VT. AGENCY OF TRANSPORTATION
HARDWICK #BHF 030-2(18)S
BRIDGE # 67
VT15 OVER COOPER BROOK

APPROACH POSTS AT SIDEWALK

SURFACE PREP: NONE
FINISH: BLACK ANODIZE
FOR: F.R. LAFAYETTE, INC.
DR: WM 9-24-09
CHK: B 9-24-09
DWG. NO. BR-2965
JOB NO. AB07010-1001
SHEET F2 OF 6

STANDOFFS

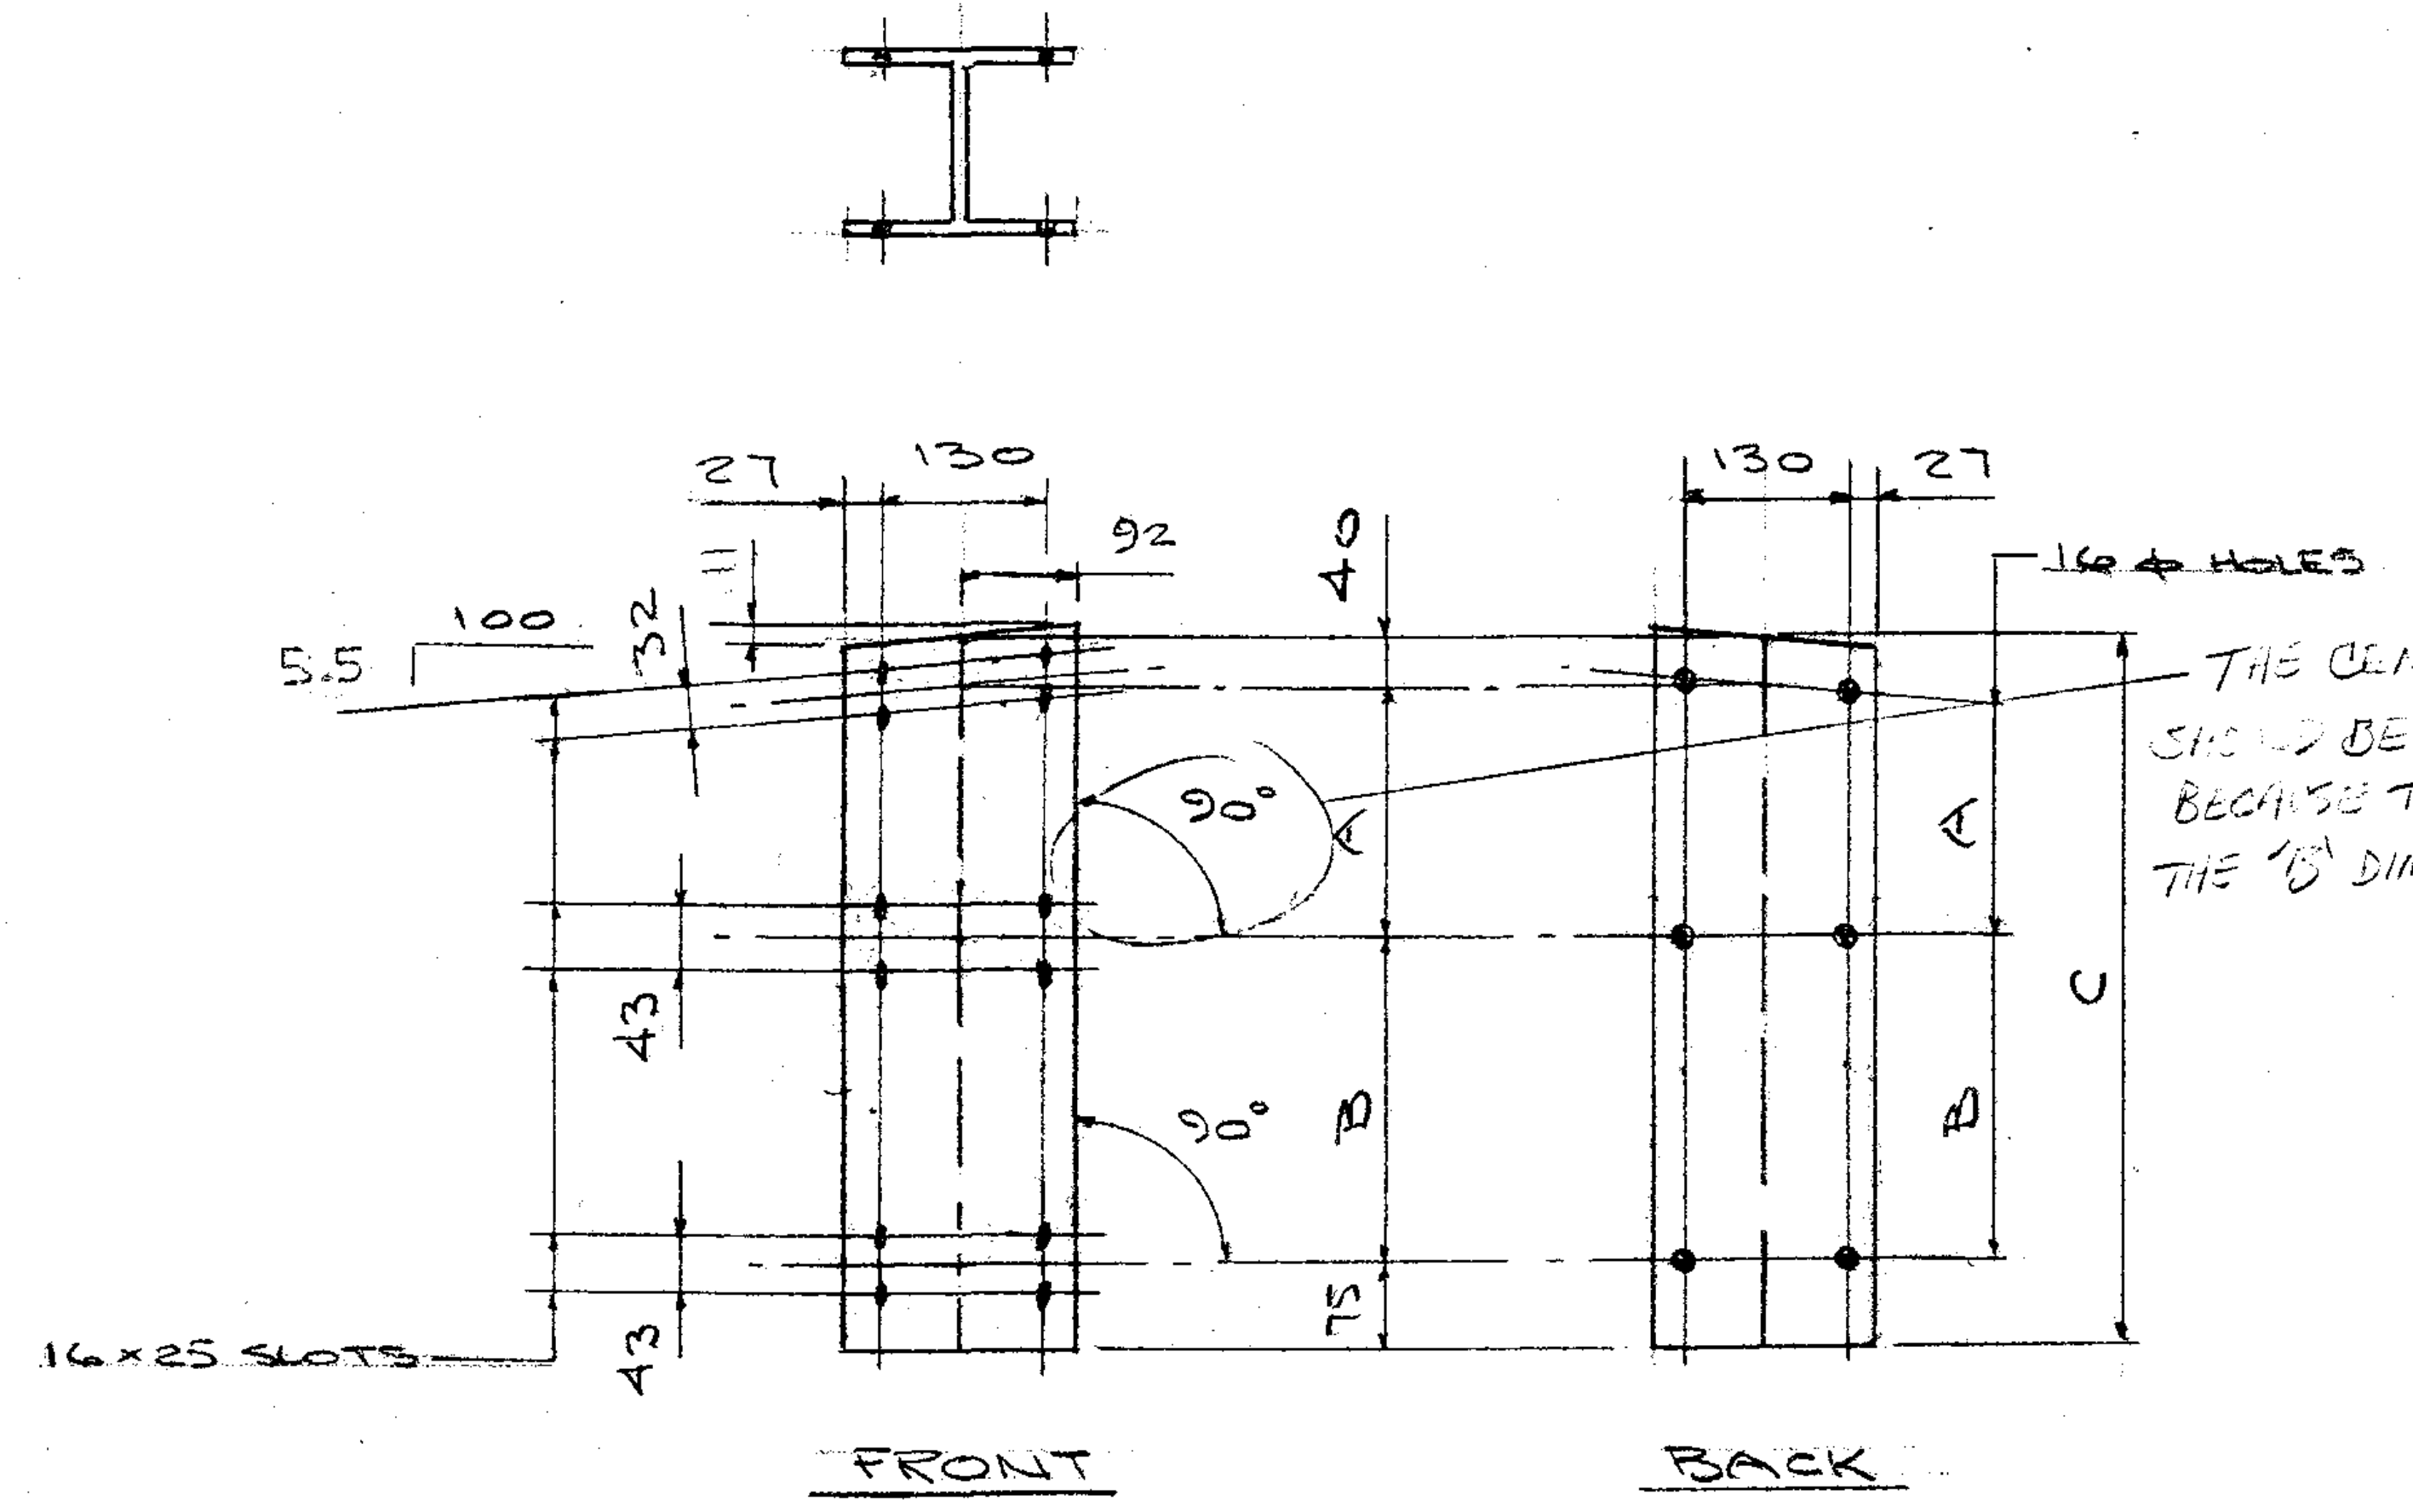
THE CENTER ROW OF BOLT HOLES SHOULD BE ANGLED STRAIGHT BECAUSE THE RAILING IS ANGLED AND THE "B" DIMENSION IS VARYING
